ADDENDUM

JLG 16098 Bottineau Ridge II Apts

Issued: December 07, 2017

ADDENDUM #: 01

PRELIMINARY PLAT

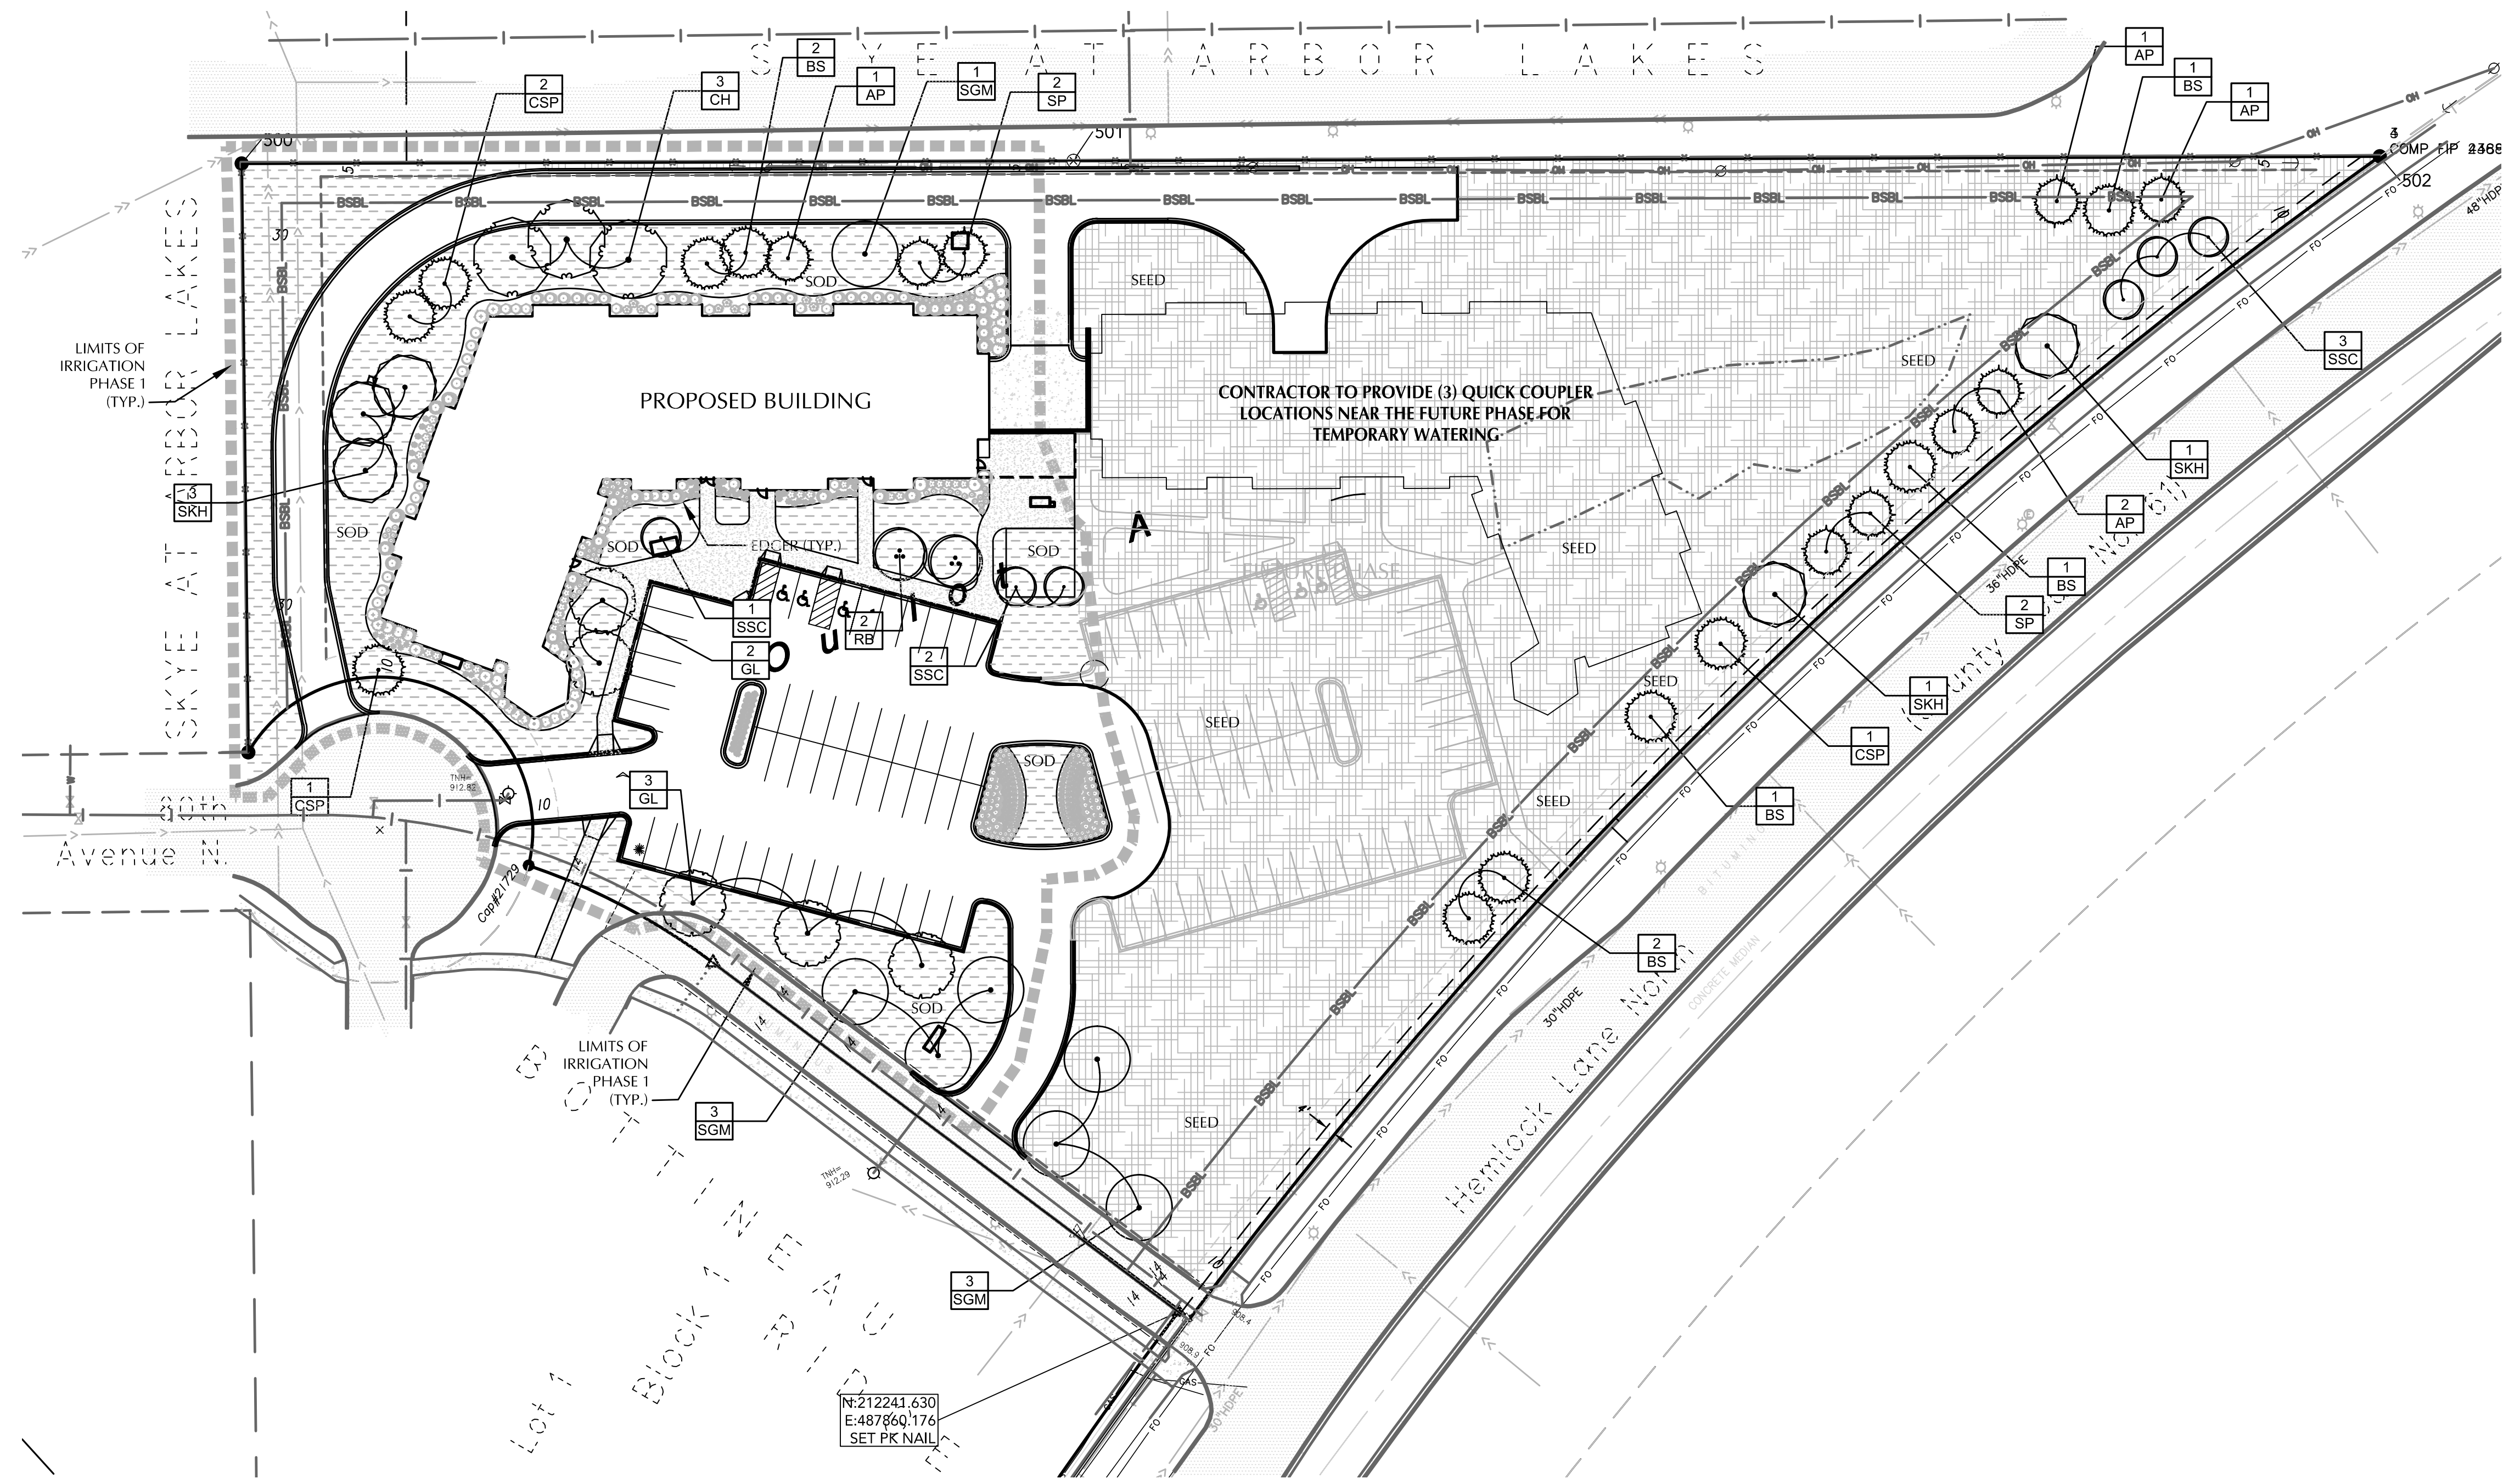
1. G100 COVER SHEET. See G100
 - o Added building address.
 - o Added sheets C-1 SURVEY & C-3 PRELIMINARY PLAT to the drawing index.
 - o Added sheet L-2 LANDSCAPE PLAN. Revised LANDSCAPE NOTES & DETAILS to sheet L-3.

LANDSCAPE PLAN
L-1

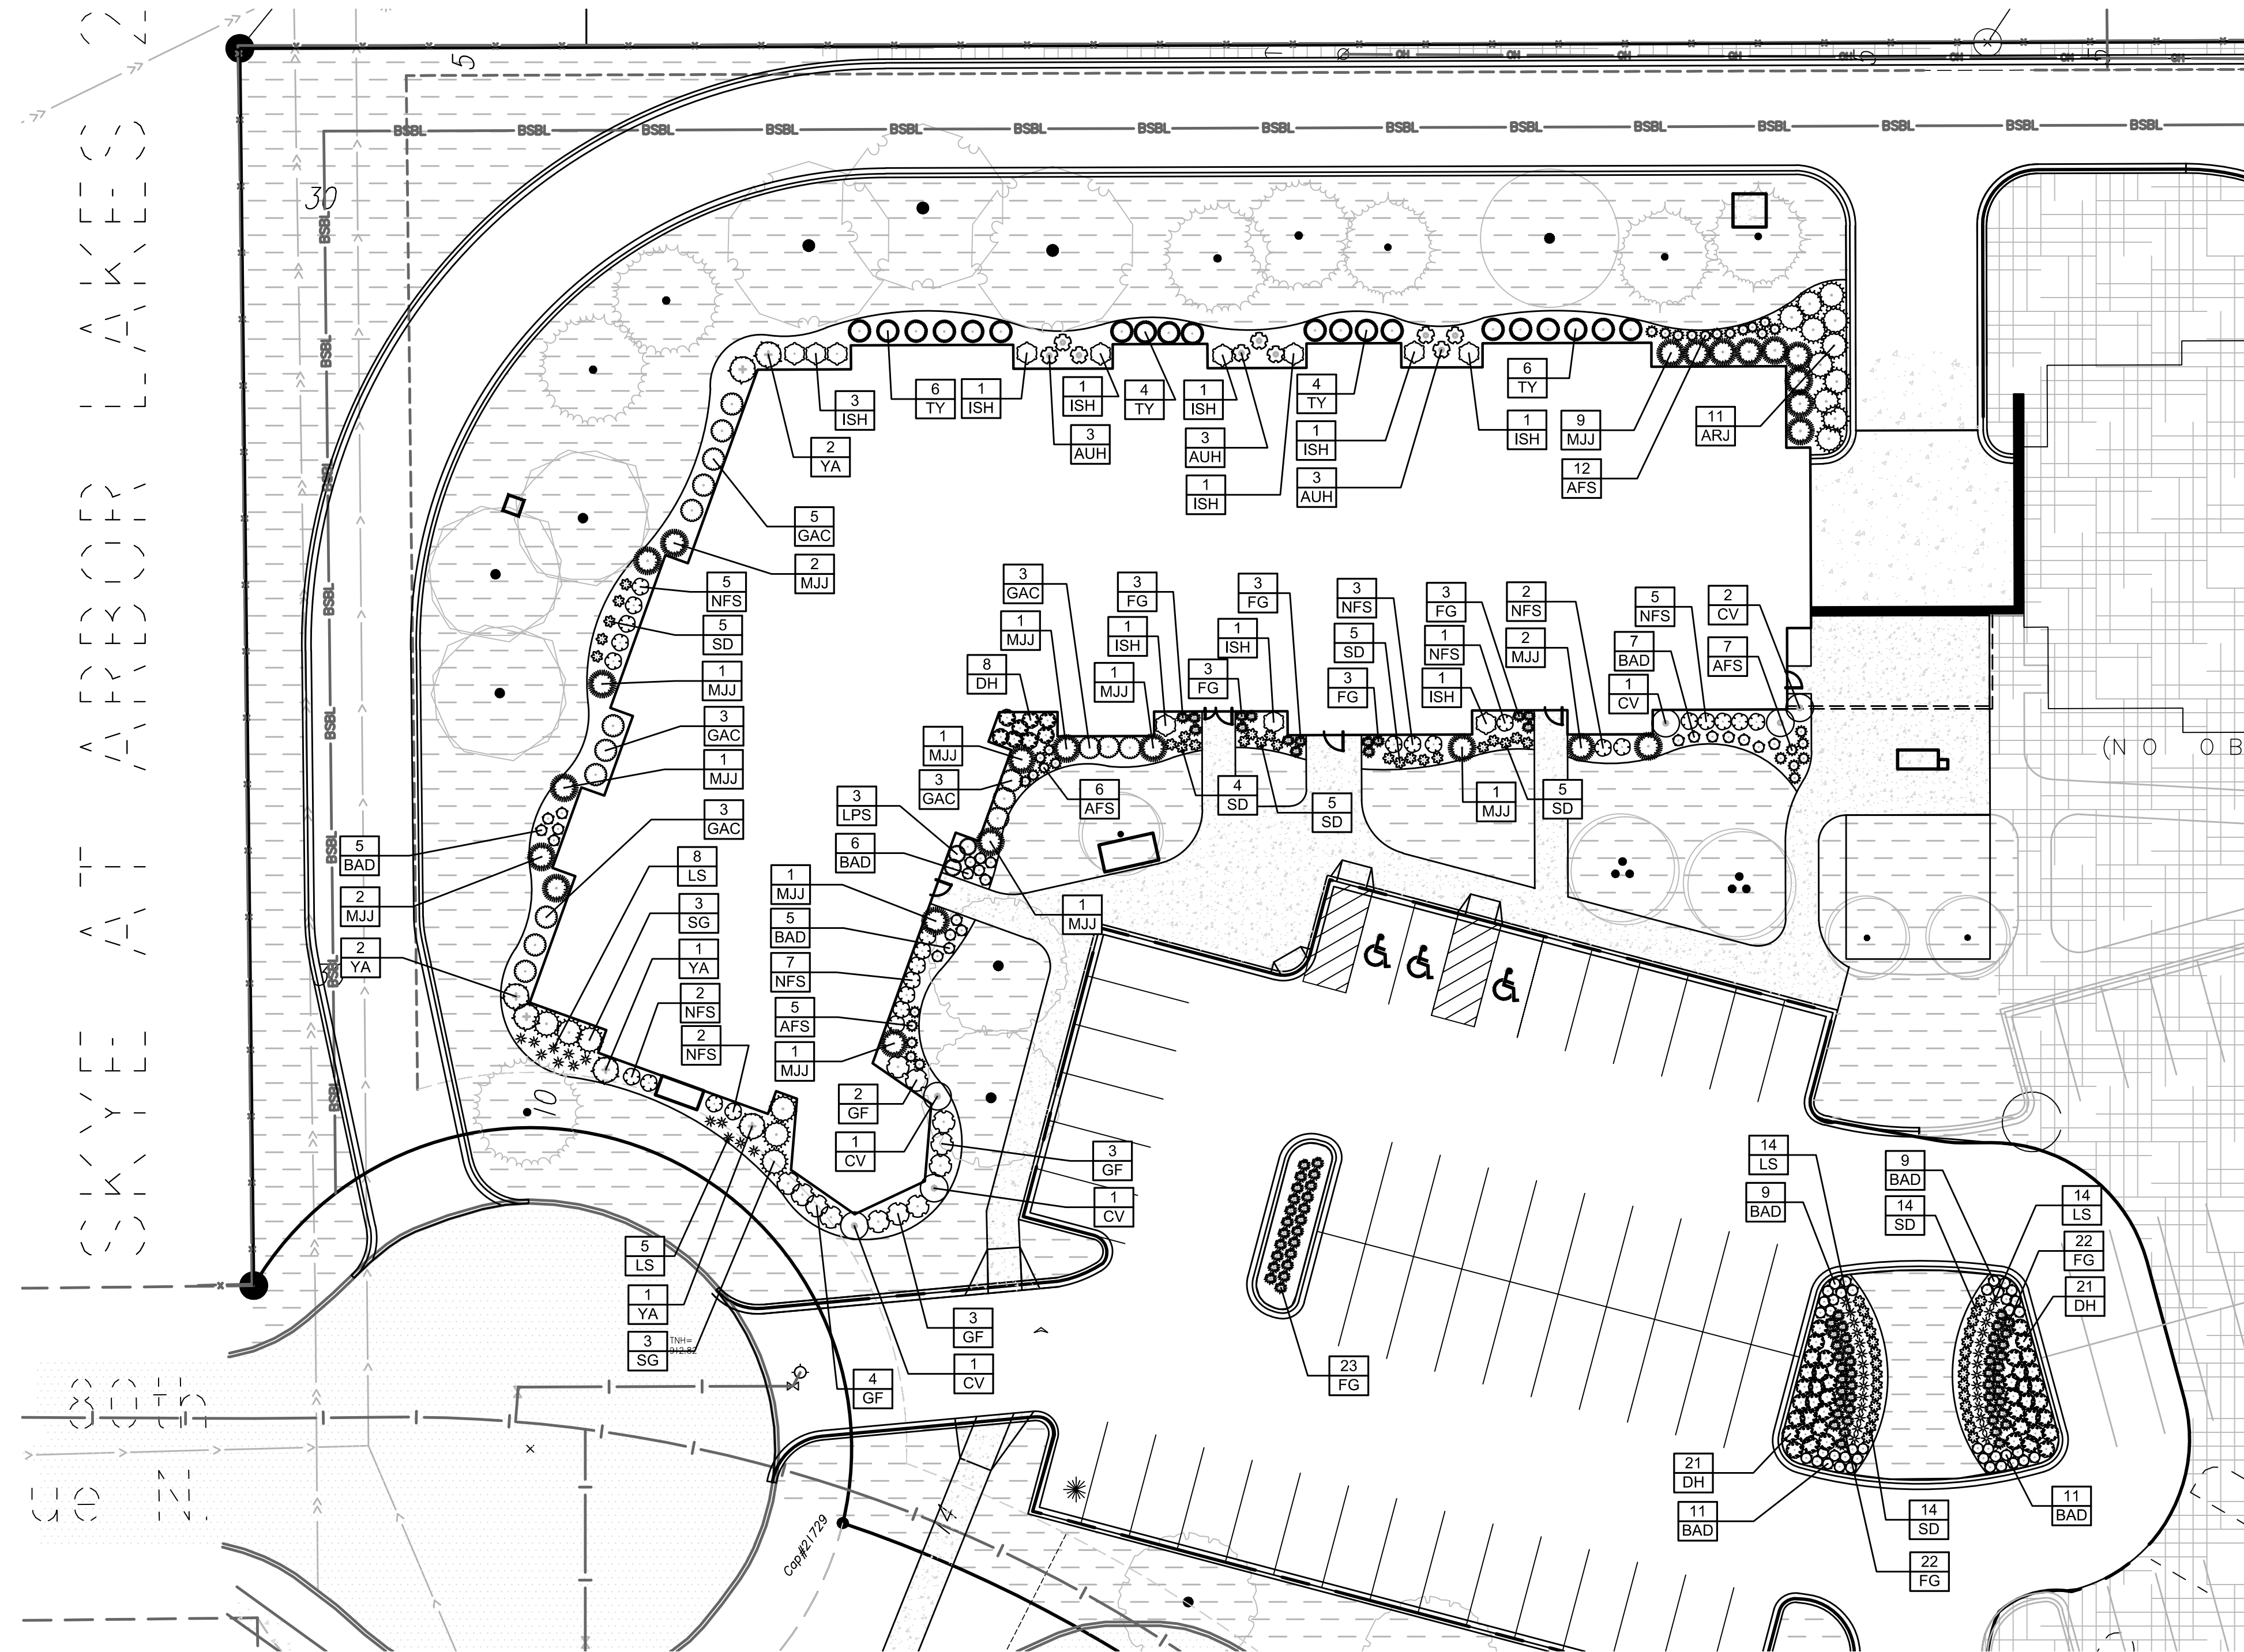
2. G110 LIFE SAFETY PLANS. See Sheet G110
 - o Updated Fire Code to most current code.
3. L-1 LANDSCAPE PLAN. See Sheet L-1
 - o The landscape plan was updated from the approved city submittal documents. Plan subtracts tress to be planted in a future phase. Plan includes species labels for shrub/perennial plantings.

1 ADDENDUM 1 - THE LANDSCAPE PLAN WAS UPDATED FROM THE APPROVED CITY SUBMITTAL DOCUMENTS. PLAN SUBTRACTS TREES TO BE PLANTED IN A FUTURE PHASE. PLAN INCLUDES SPECIES LABELS FOR SHRUB/PERENNIAL PLANTINGS.

1
L-3
DECIDUOUS TREE PLANTING DETAIL

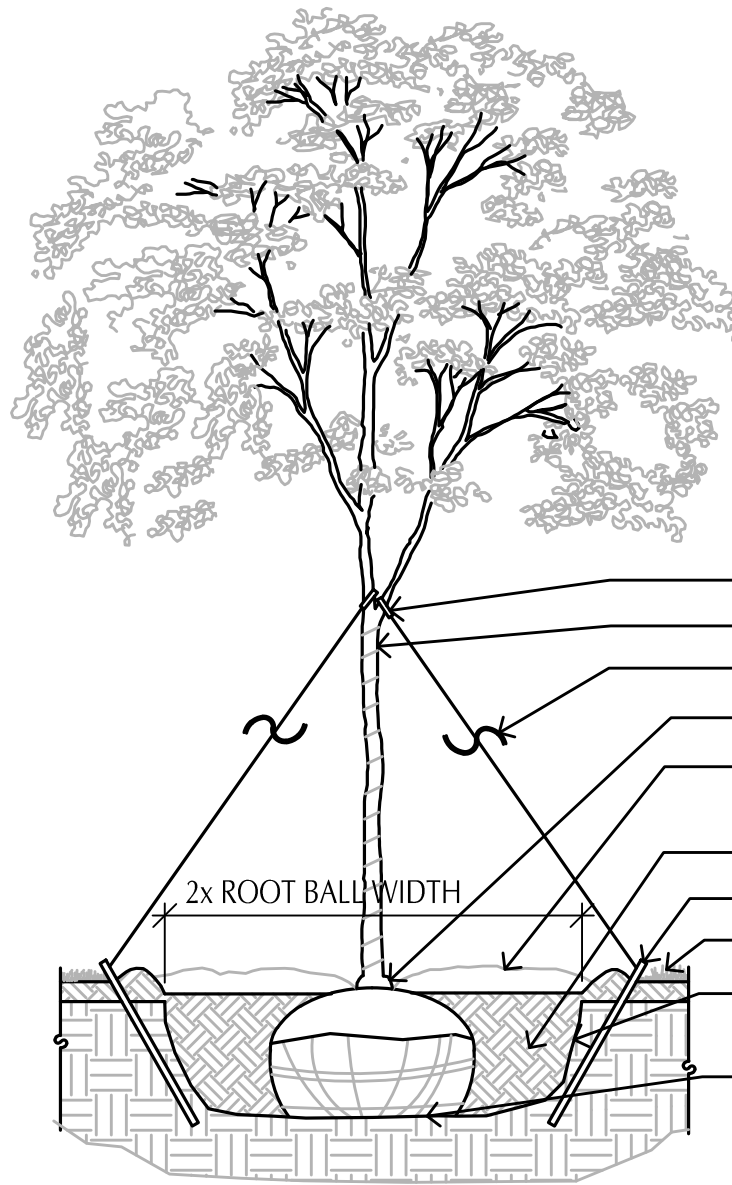
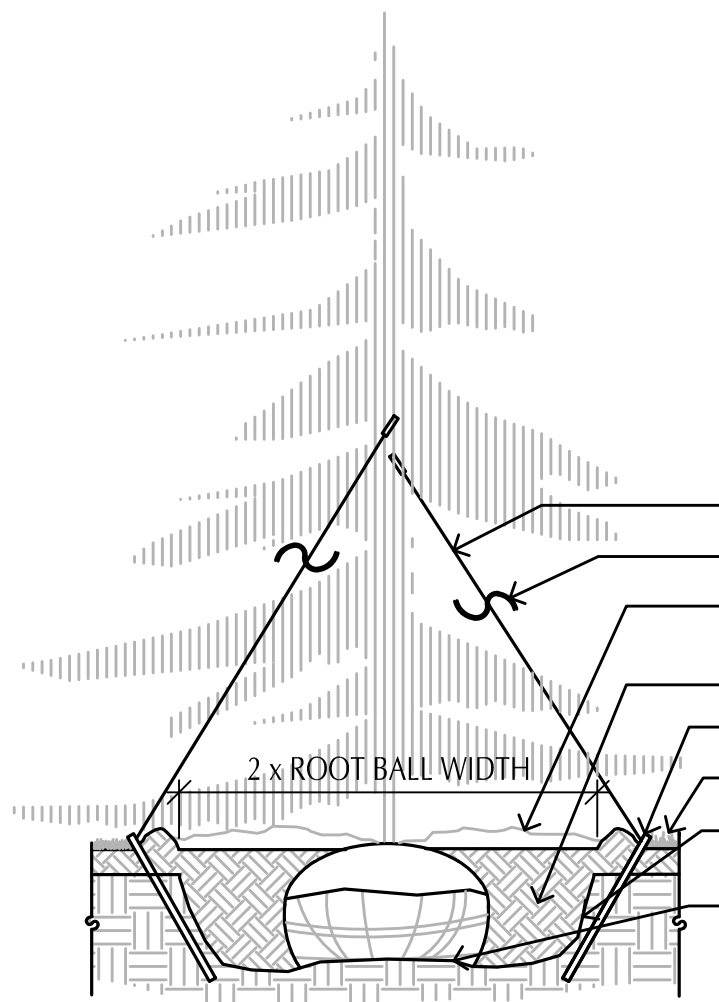
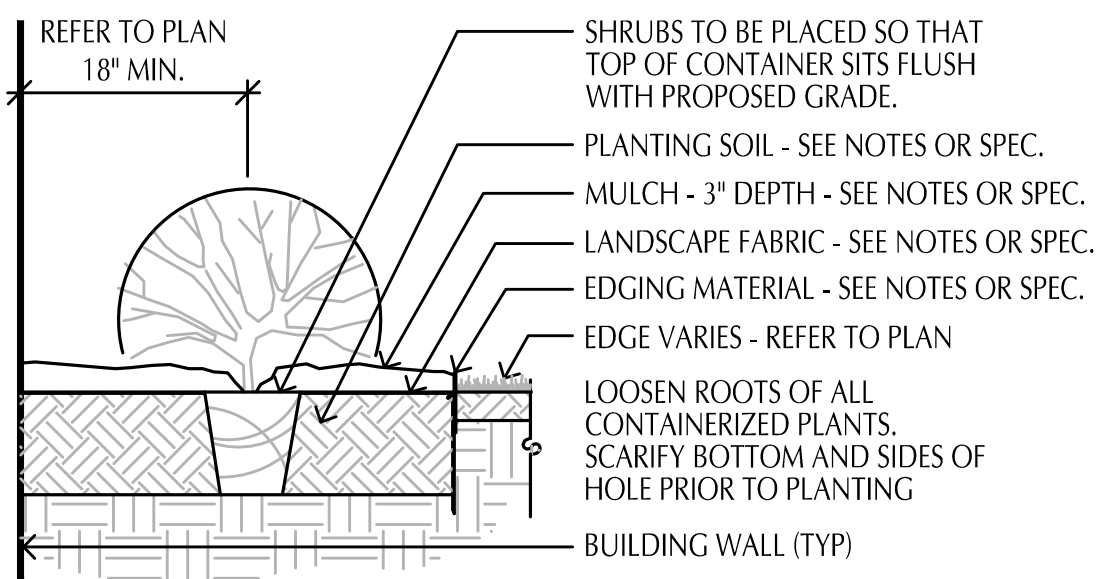
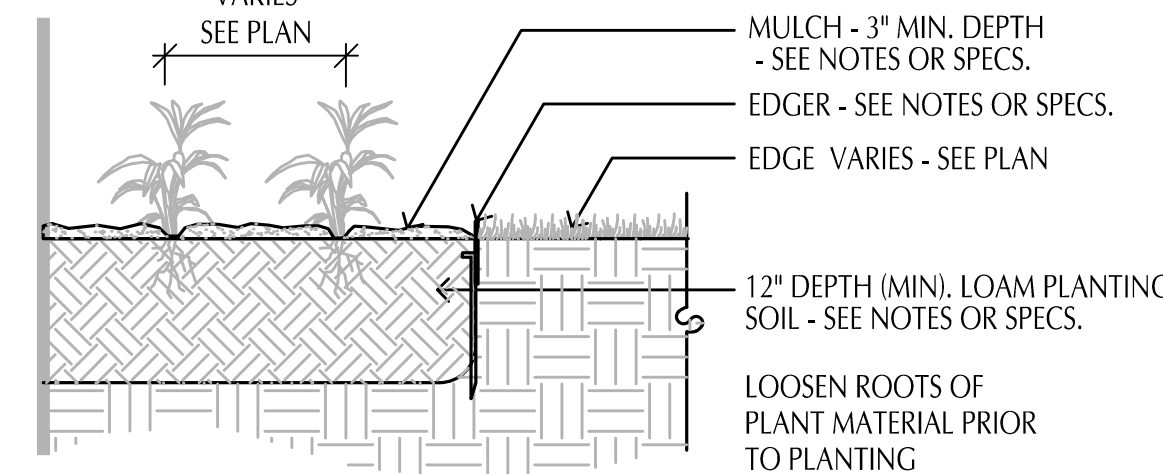
5. L-3 LANDSCAPE NOTES & DETAILS. See Sheet L-3
 - o The landscape plan was updated from the approved city submittal documents. Plan subtracts tress to be planted in a future phase. Plan includes species labels for shrub/perennial plantings.

1
ADDENDUM 1 - THE LANDSCAPE PLAN WAS UPDATED FROM THE APPROVED CITY SUBMITTAL DOCUMENTS. PLAN SUBTRACTS TREES TO BE PLANTED IN A FUTURE PHASE. PLAN INCLUDES SPECIES LABELS FOR SHRUB/PERENNIAL PLANTINGS.
